**Report to General Manager**

SUBJECT: Victoria Cross - Over Station Development (OSD)**AUTHOR:** Geoff Mossemeneer, Executive Planner**ENDORSED BY:** Joseph Hill, Director City Strategy**EXECUTIVE SUMMARY:**

Figure 2 - Proposed Victoria Cross OSD building envelope (axonometric diagram from southwest)

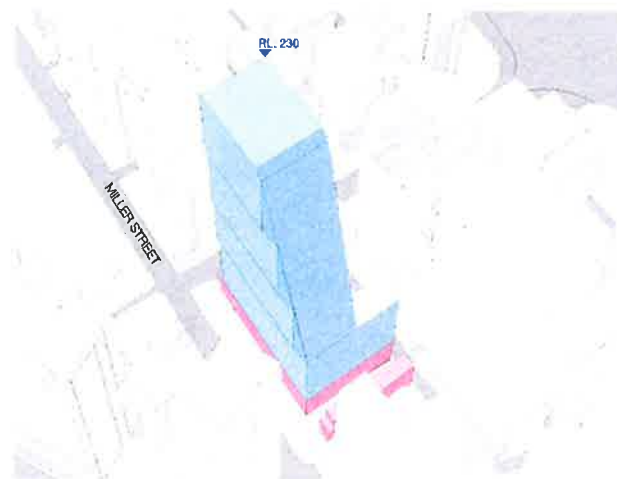
It is to be noted that the height of the proposal in part results from the provision of an entry foyer of significant height. This area and the common plant rooms could be adapted in refined versions of this proposal for other purposes.

Figure 2 – Proposed Height of Buildings Map
Source: North Sydney Centre Planning Proposal (amended post-exhibition)

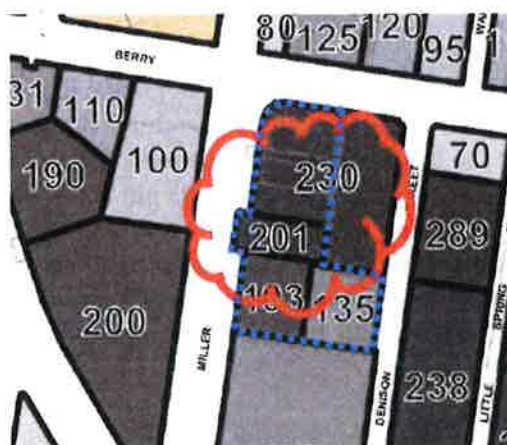
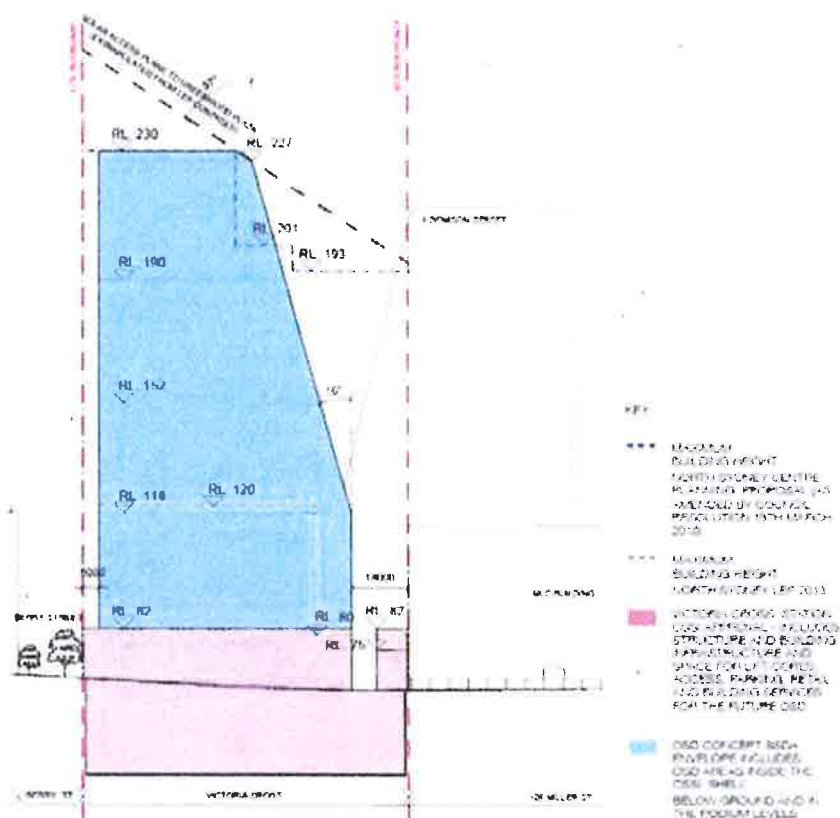
The proposed building envelope complies with the Height of Buildings Map in the North Sydney Centre Planning Proposal, with the exception of a small portion of the RL 201 section of the map. Over this section, the proposed building envelope has a maximum height of RL 230, resulting in a maximum non-compliance of 29m (or 14%).

It is noted that the Clause 4.6 request refers to the heights finally adopted by Council in the Planning Proposal and not the heights as exhibited in that Proposal. The Clause 4.6 request is not supported under the current controls. Determination of the application should be deferred until the planning proposal is gazetted. This has been the standard practice of Council and reinforced by the Joint Regional Planning Panel and Sydney North Planning Panel. The minor breach of the planning proposal heights would be acceptable as there is minimal impact with regard to overshadowing and the bulk and scale of the building is not significantly increased.

Submission: Determination of the application should be deferred until the planning proposal is gazetted.
